ADDENDUM 1

DATE: April 18, 2024

PROJECT: OUSD, Wagner Ranch Elementary School Path of Travel Work

FROM: HKIT Architects

A1.01
COPYRIGHT © 2016 HKIT ARCHITECTS

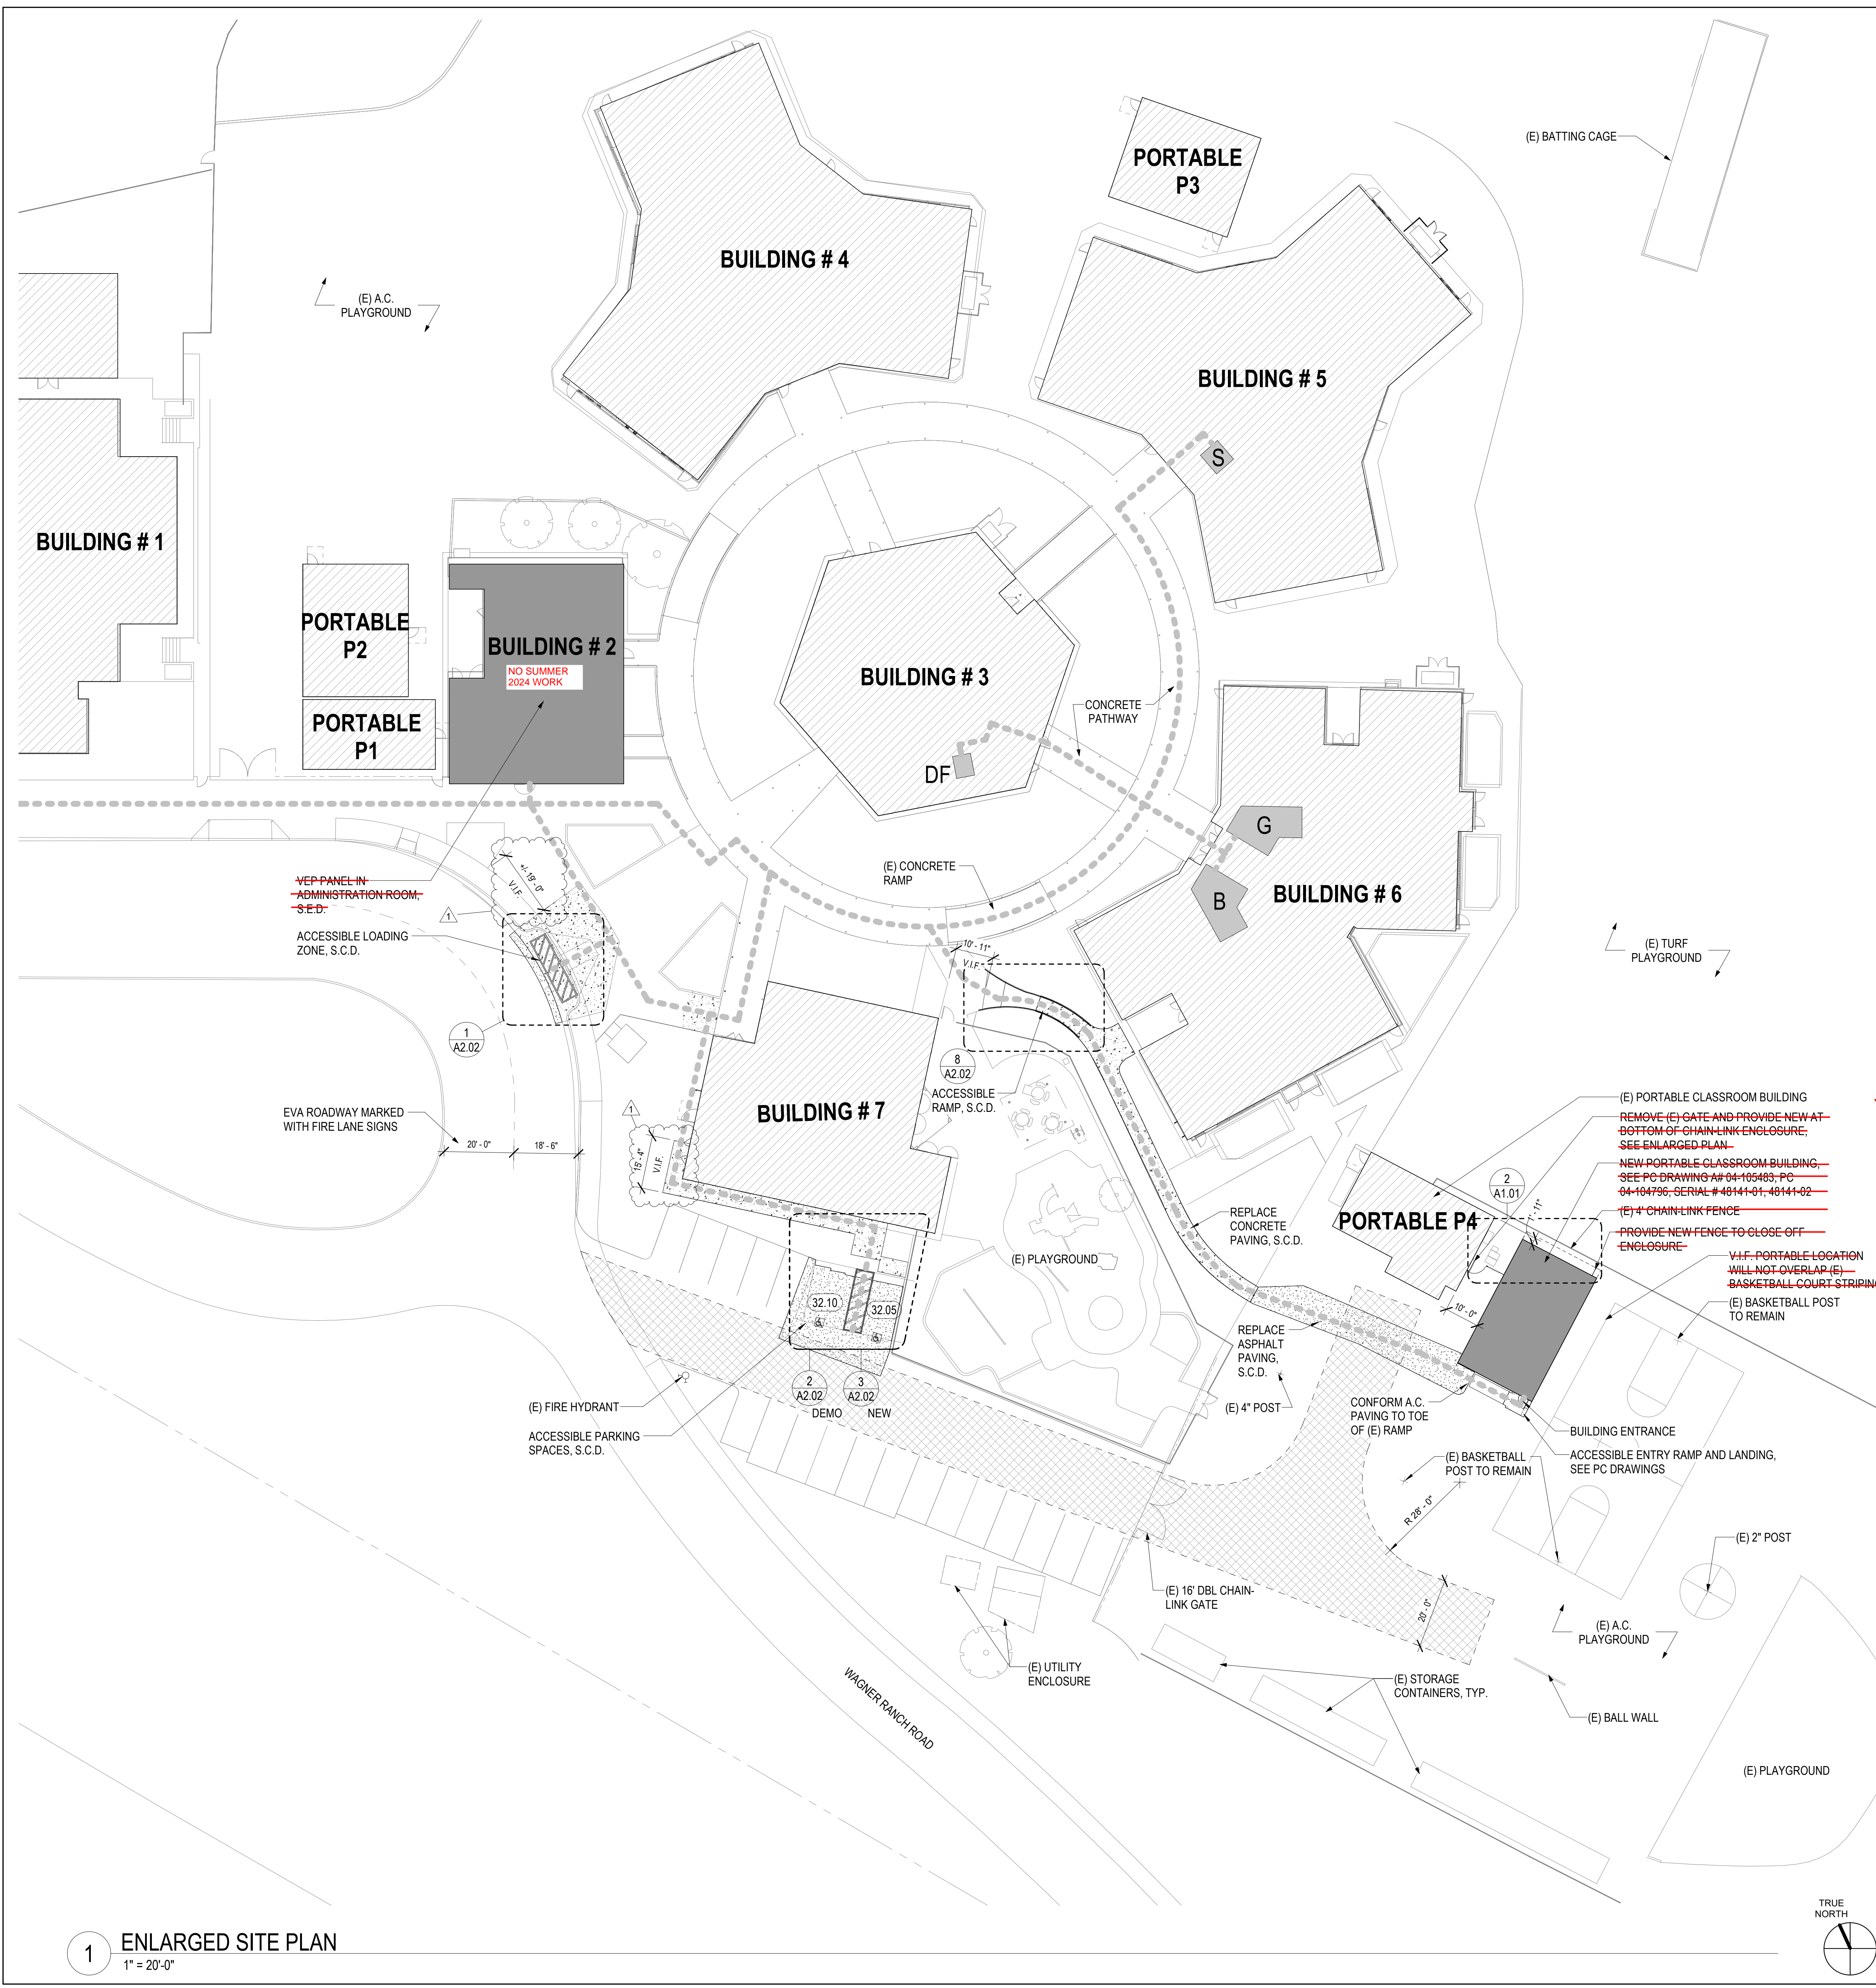
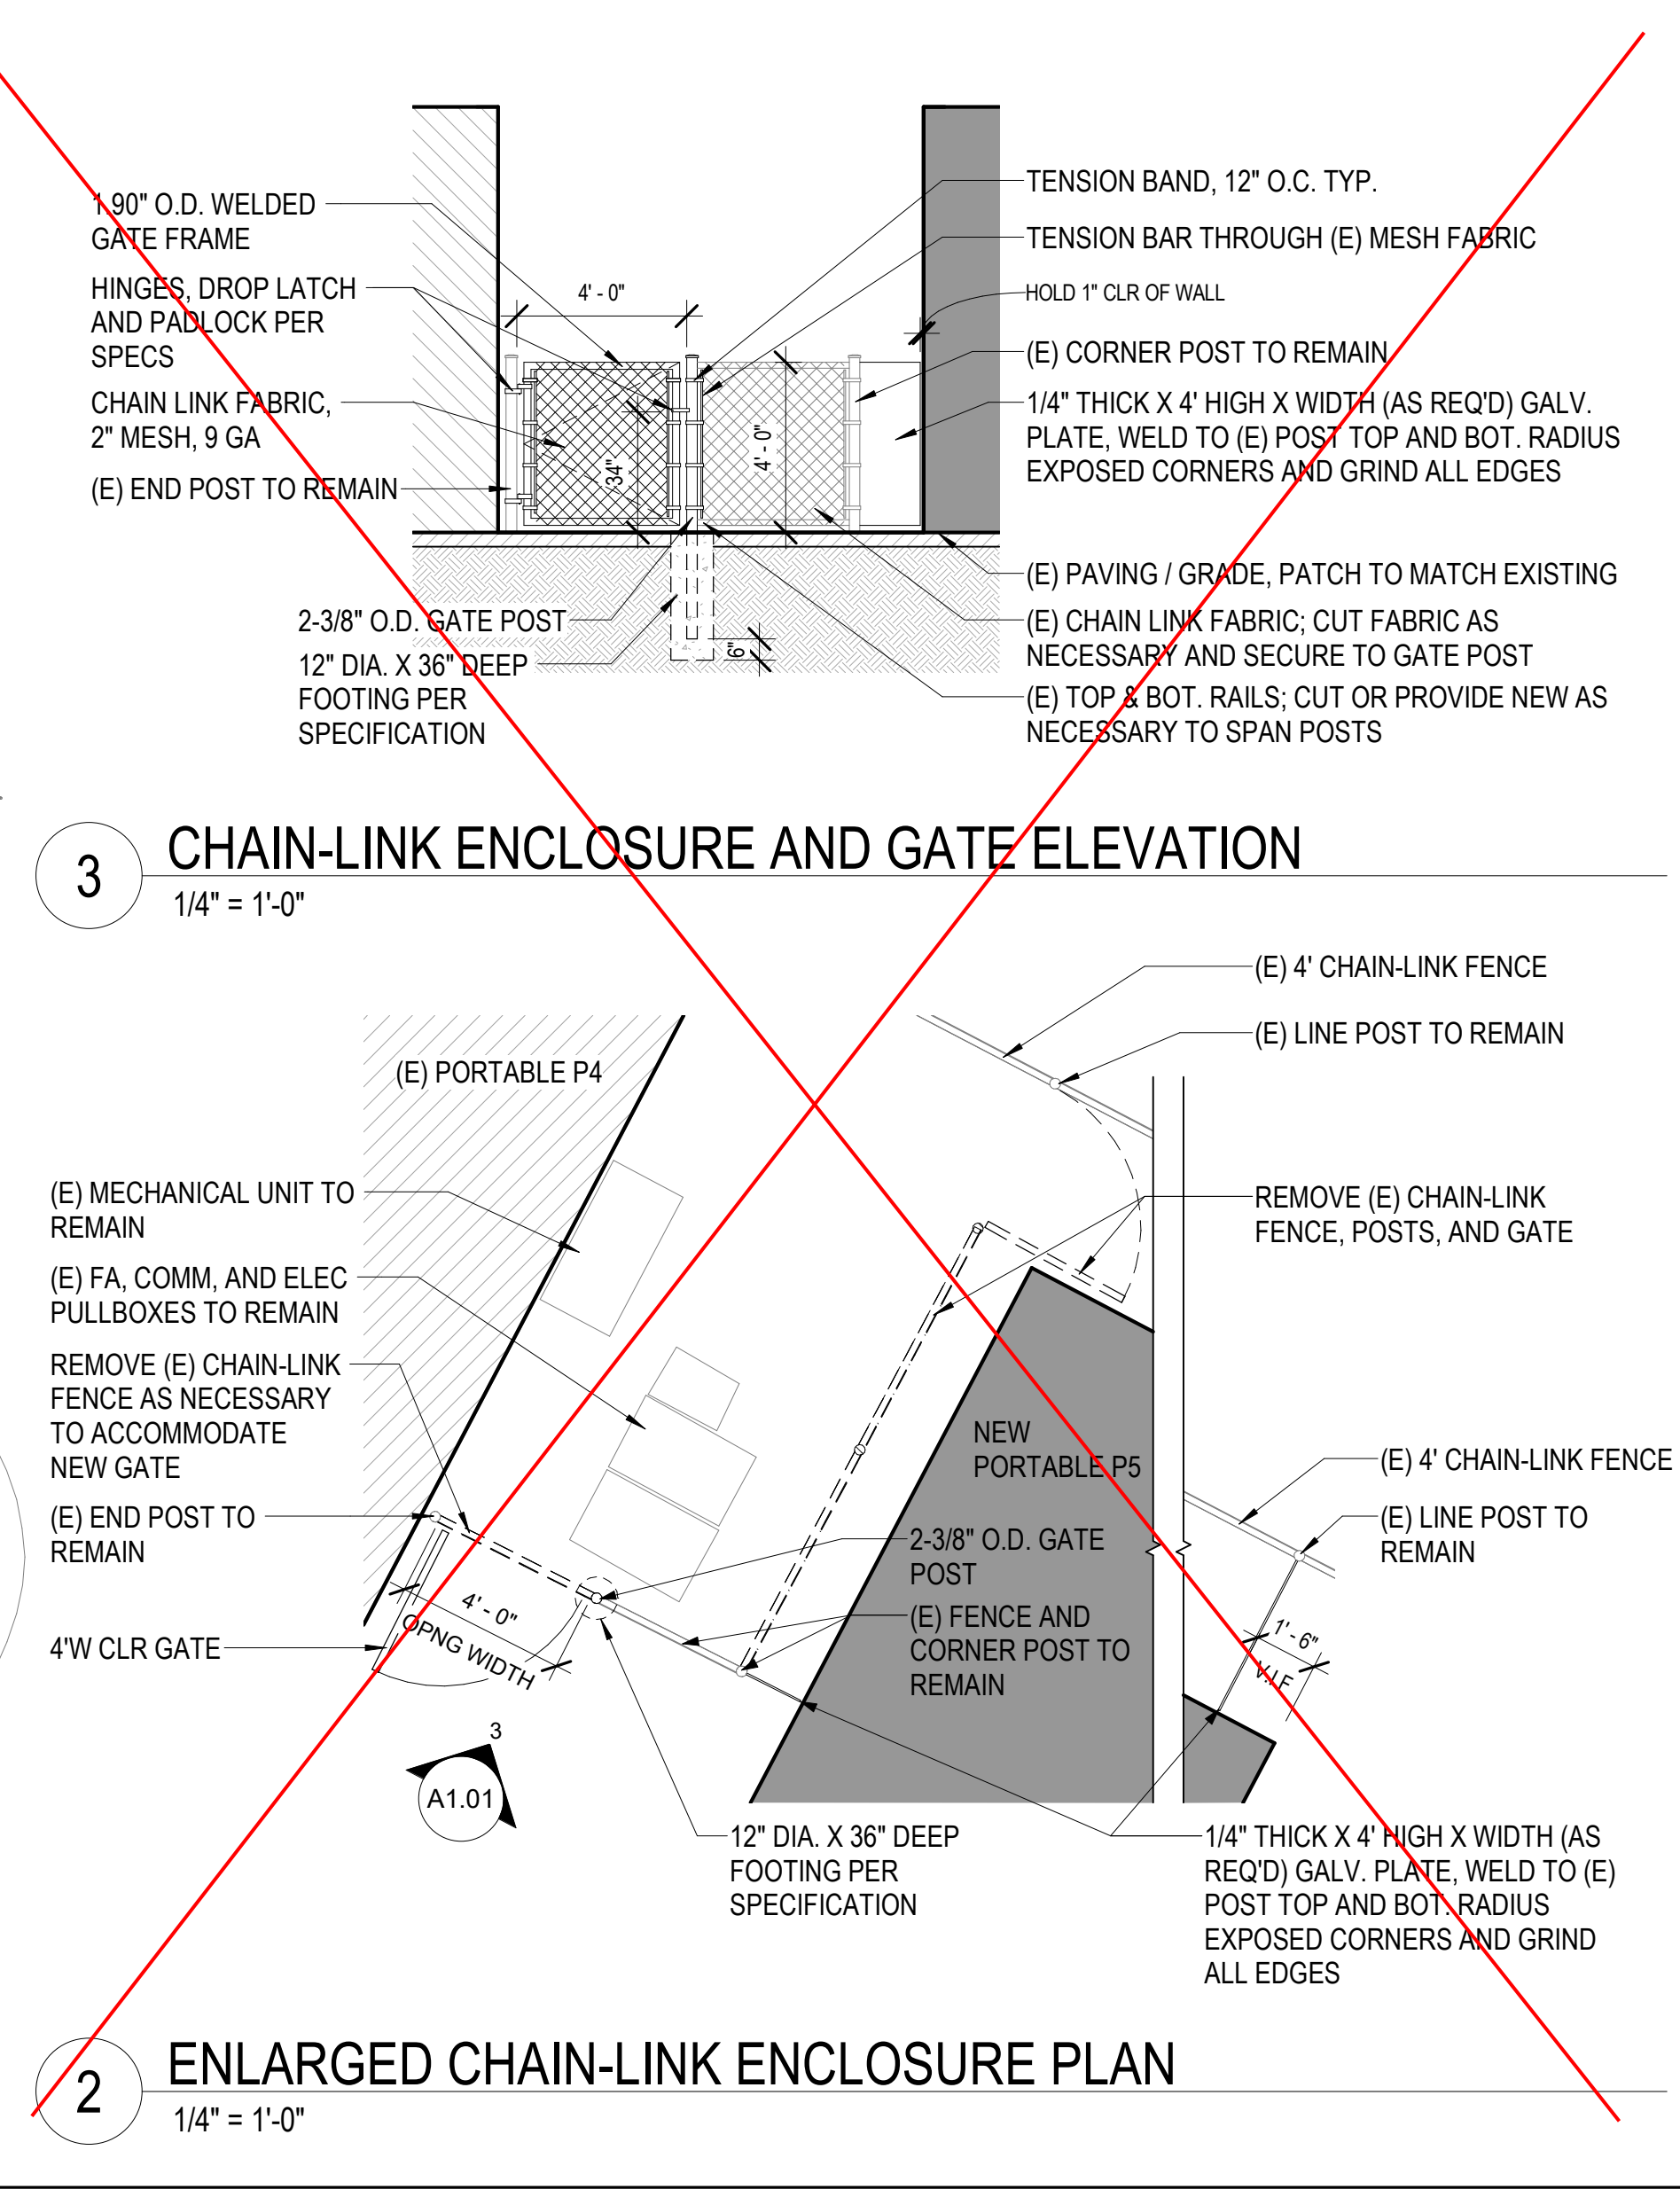
1-1 Subject: Locations of new concrete work at parking and drop off

Description of Change: Added approximate dimensions to locate new concrete work. All locations must be field verified with civil grading plans.
